Sydney Metro West

Sydney Olympic Park Over and Adjacent Station
Development

Addendum to Appendix X - Preliminary Integrated
Water Management Plan

Figure 4-2 MUSIC Model for Sydney Metro Olympic Park Catchment

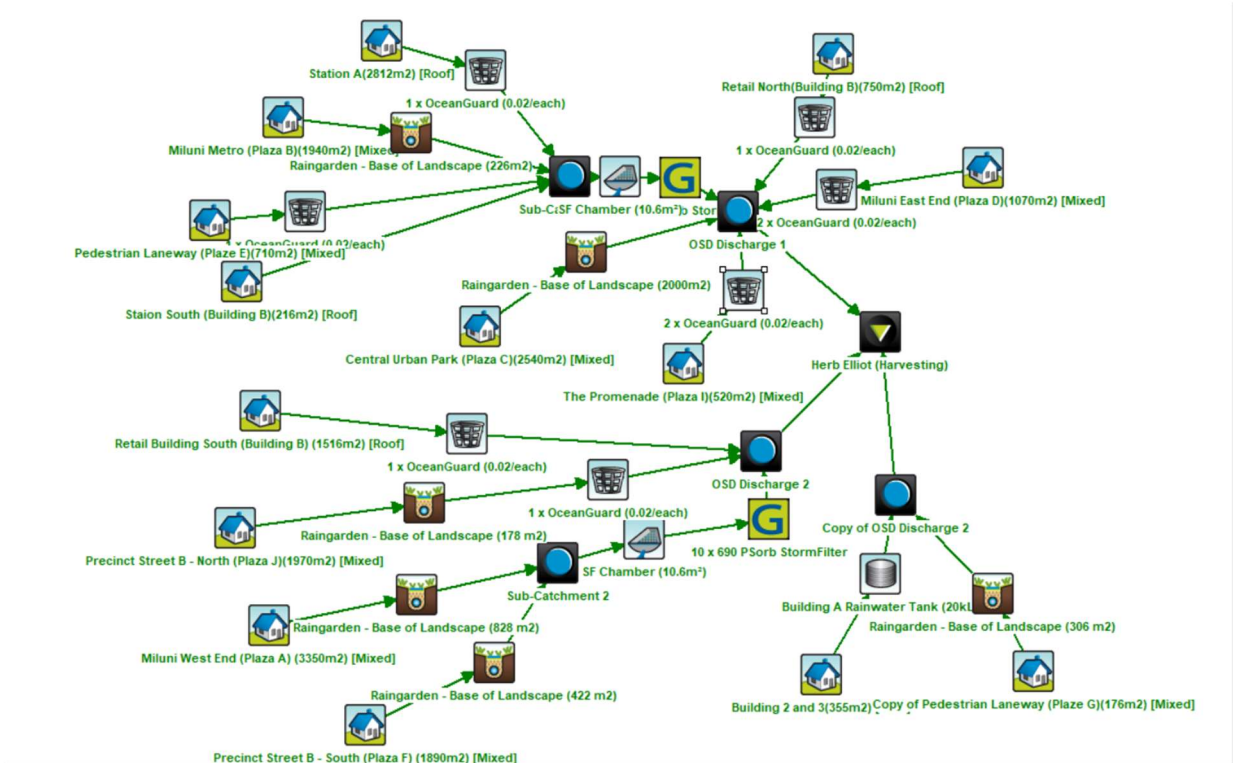
Appendix X: Integrated Water Management Report	MUSIC calculations appear to have been based on typical data, assuming the ability of such basins (rain gardens) to remove pollutants while the trees/sedges are growing well. But given three tall buildings on the development site, two tall buildings in the nearby site and also more are likely within 100m radius, the shadows are supposed to diminish the ability of such trees/sedges to grow well. The reduced growth must be diminishing the pollution reduction capacity. It is not clear if the MUSIC calculations have considered reduced level of pollution reduction performance and, hence whether still meeting the SOPA WSUD Guidelines. Detailed Integrated Water Management Report should (a) take into consideration projections from Detailed Shadow Impact Report regarding MUSIC calculations for Bio-retention basins (b) align with SOPA WSUD Guidelines.	Refer to Section 4.2 for response. MUSIC model have been updated by selecting the vegetation with ineffective nutrient removal plants

It should be noted that both Tree Pits/Raingardens were modelled as Vegetated with Ineffective Nutrient Removal Plants to account for the limited sunlight projected within the Concept SSDA site boundary.

The MUSIC setup and results are shown in Figure 4-2 below.
